MODIFICATION REQUEST:

Blocks 6 and 7, Central Park

MP 11_0091 MOD 1

Secretary's
Environmental Assessment Report
Section 75W of the
Environmental Planning and Assessment Act 1979

Figure 2: Proposed amendment to Level 5 of No. 2-10 Kensington Street illustrating location of ventilation added to northern facade (Source: Architectural plans from Proponent's Application)

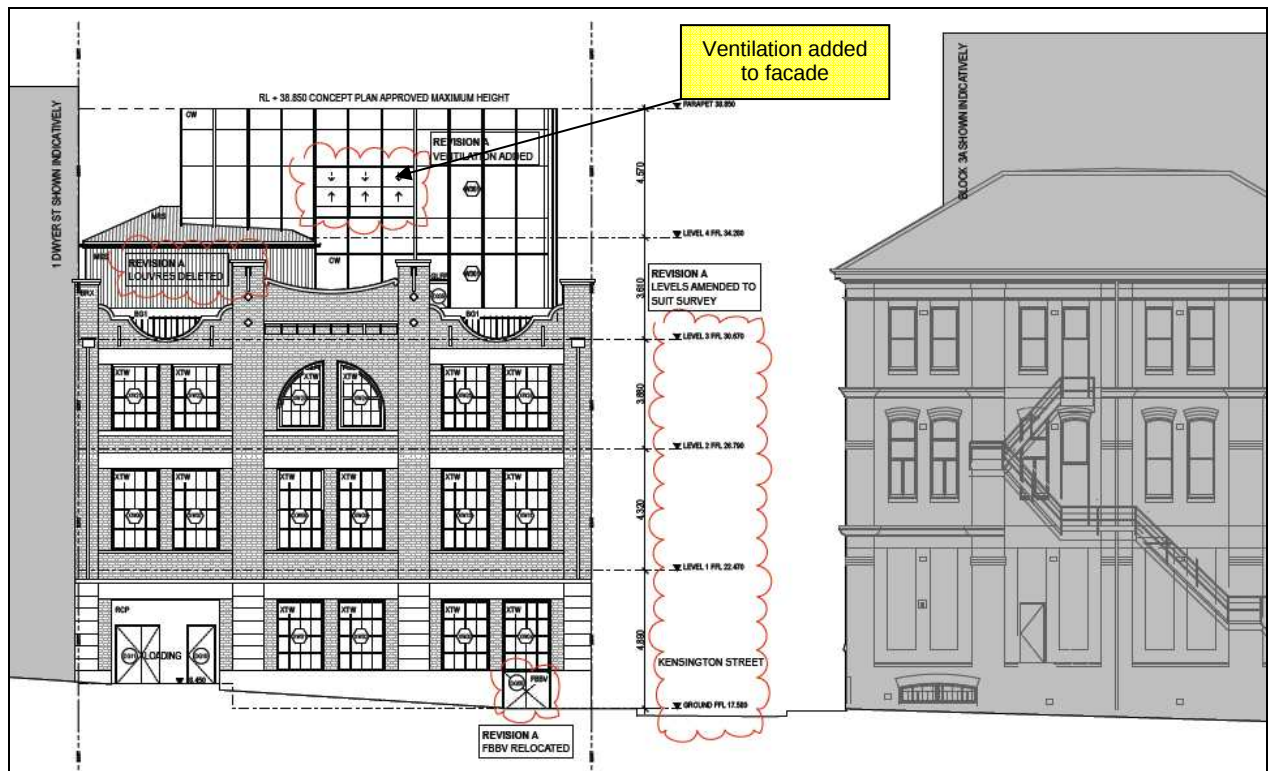
- inclusion of external ladders;
 - replacement of exterior wall to No. 12;
 - ventilation included within the glass screen to be constructed on No. 2-10 on Level 5;

The proponent seeks to undertake minor internal modifications to the approved development, as illustrated in **Figure 2** and **3**. These predominantly include modifications to bathroom facilities and plant rooms, which are proposed to improve the efficiency and access throughout the buildings and into the rear laneways. The department supports these minor modifications that provide greater access to these areas.

Figure 3: Proposed amendments to ground floor of development (Source: Architectural plans from Proponent's Application)

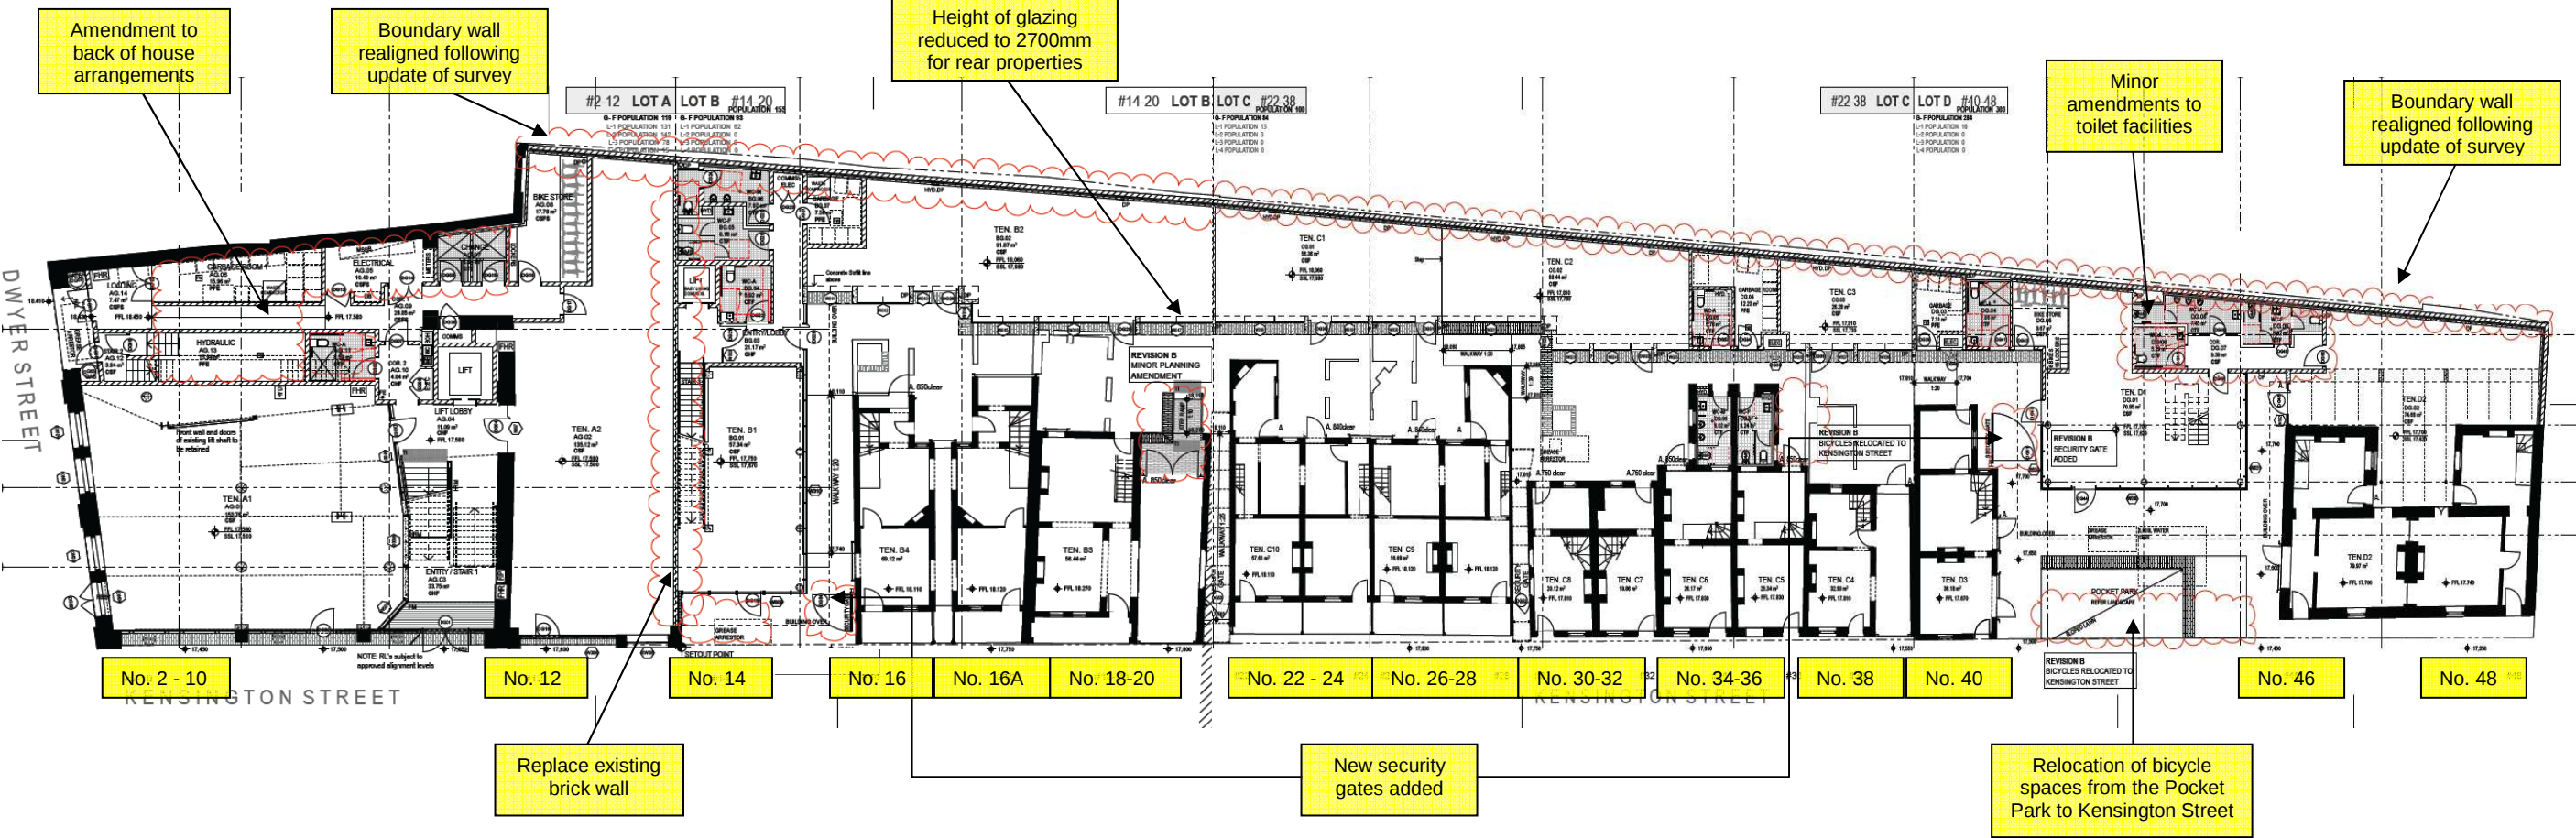
The modifications are detailed in **Figures 3 and 4** within Section 2 of this report.

Another proposed amendment is the replacement of the existing dividing wall between No. 12 and 14 (ground and first floor), which was originally proposed to be retained. The existing wall has been found to be unstable and unsuitable for retention. The proponent's heritage consultant advised that the replacement of this internal wall will not have any negative impacts upon the heritage significance of the site. It is noted that Council also did not raise any concerns with this modification on heritage grounds. The department therefore supports this internal modification.

Figure 6: Approved (left) and proposed (right) modifications to parapet height at No. 40-42 Kensington Street (Source: Proponent's Application)

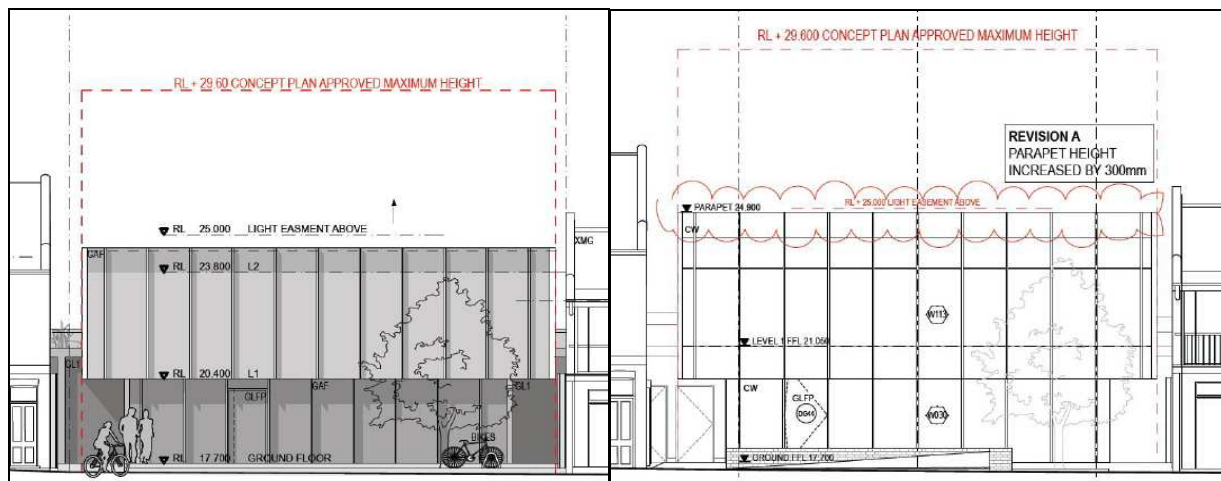
The proposed 300mm increase in height to the glass parapet height at No. 40-42 (raising to a maximum RL 24.90) will be visible from Kensington Street. A comparison between the approved and proposed elevation is provided at **Figure 6**. The increase in height of the parapet follows a refinement of the design to improve the appearance of the glass parapet to Kensington Street and ensure that it is of a similar height to the ridgeline of the buildings to the south.

The increase in height of the parapet does not impact upon the building light easement height of RL 25.00, which is provided to ensure light onto the Kensington Street public domain area. On this basis, the department supports this increase, noting that the minor increase will have minimal impacts on the external appearance and amenity of the Kensington Street public domain.
